FINAL
ENVIRONMENTAL IMPACT REPORT

VINEYARDS AT EL DORADO HILLS
(SCH: 2017102026)

AUGUST 2019

**EXHIBIT O - FINAL ENVIRONMENTAL
IMPACT REPORT**

Figure 3.11-3

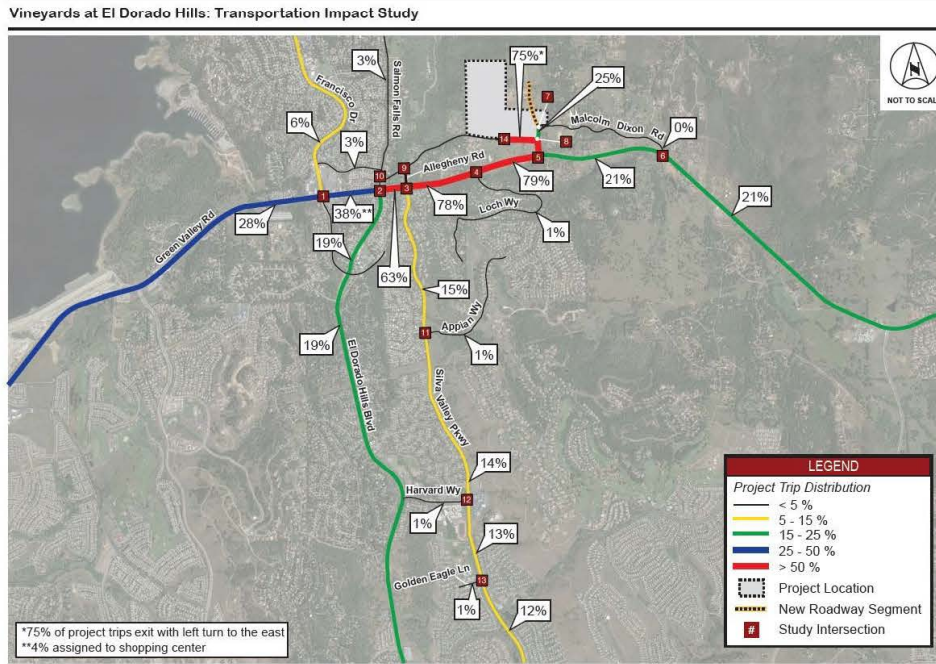
A-2 cont'd

As shown in Figure 3.11-3 on page 3.11-37 of the Draft EIR, under the Existing condition, 1% of the proposed project trips would head south on Loch Way from Green Valley Road. As noted on pages 3.11-15 and 3.11-16 of the Draft EIR, the El Dorado County Travel Demand Model (TDM) was used both as the basis to establish the relative assignment of proposed project trips, and to establish background traffic estimates for analysis scenarios (additional discussion on the specific application of the TDM can be found within each scenario's discussion section in Section 3.11.5). While the County originally provided the most recent iteration of the County's model at the onset of the project¹, subsequent coordination with the County resulted in additional revisions to that model for use in this study². The project trip distribution percentages that resulted from analyses completed for this study are provided in Figure 3.11-3 (Existing 2015) and Figure 3.11-4 (Future 2025).

Based on the assumed trip distribution, the net new external trips generated by the project were assigned to the street network, as shown in Figure 3.11-5 (2015) and Figure 3.11-6 (2025). It is noted that additional trip diversion occurred during the Existing (2015) Plus Proposed Project conditions with the incorporation of Chartraw Road construction (see Figure 3.11-7). No revisions to the Draft EIR are necessary in response to this comment.

Revised Figure 2.0-7. Water Plan

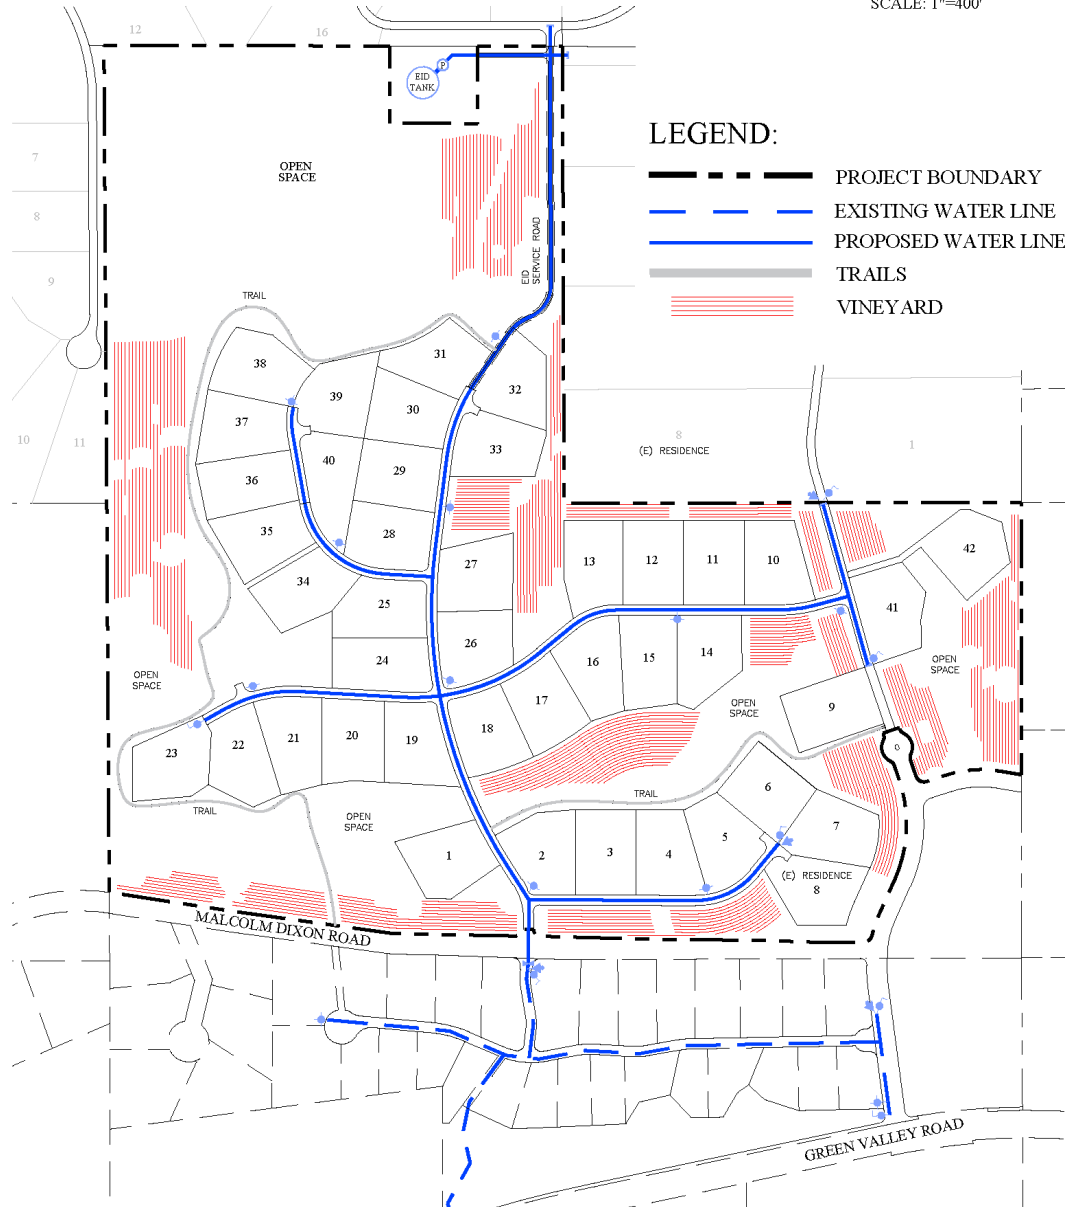
3.12-16 Draft Environmental Impact Report – Vineyards at El Dorado Hills
 These "Roads" are not shown on Figure 2.0-7. Where are they shown? valve in Malcolm Dixon Road

Figure 2.0-7 on page 2.0-21 of Chapter 2.0 of the Draft EIR has been replaced with the following figure:
